TENNESSEE VALLEY AUTHORITY

October 7, 1986

Enclosed is TVA's response to your letter to S. A. White dated August 4, 1986. This response addresses your 15 Watts Bar Nuclear Plant (WBN) specific cable pulling questions from an engineering/design perspective. Similar cable pulling questions at the Sequoyah Nuclear Plant (SQN) will be addressed in detail in TVA's response to your August 29, 1986 letter.

Responses to NRC questions contained in the August 4, 1986, NRC letter from B. J. Youngblood to S. A. White.

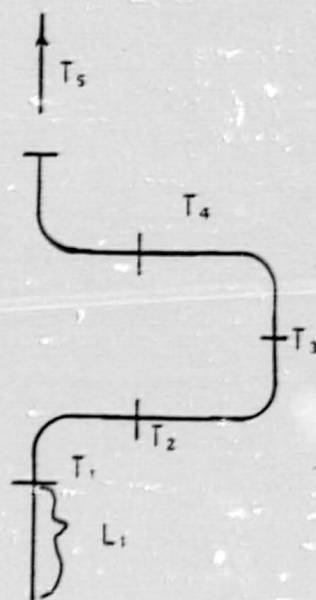
Describe in detail the process of elimination used in determining the worst-case conduits with regard to cable pulling. Include such information as the lengths of conduit considered to be too short to be of concern, the assumptions used in scoping the worst-case conditions, and the methods used to determine the 12 worst-case conduits.

The purpose of the calculations was to determine acceptability of sidewall bearing pressures (SWP) exerted on Class 1E cables in existing conduits. All Class 1E (approximately 10,400) conduits were evaluated through preliminary screening, field inspection, and detailed calculations.

(1) Developed a list of assumed worst-case configurations based on vertical conduit with four 90° bends in pulling end of conduit. The cable pull was assumed to be upward. See figure:

3" Conduit
3 Cables
 $W_c = 1.4$
 $K = 0.42$
 $R = 0.955$ ft.
 $\alpha = 90^\circ$ (1.57 rad)
Sidewall bearing pressure
(SWP) = 300 lbs/ft
(Conservatively assumed)
 W = Cable weight per foot

(2) Calculated maximum pulling tension allowable to avoid exceeding sidewall bearing pressure limits (300 lbs/ft for power and control; 100 lbs./ft. for instrumentation).

EXAMPLE:
$$T = \frac{3(SWP)R}{(3W_c - 2)}$$

$T = 391$ lbs for above figure
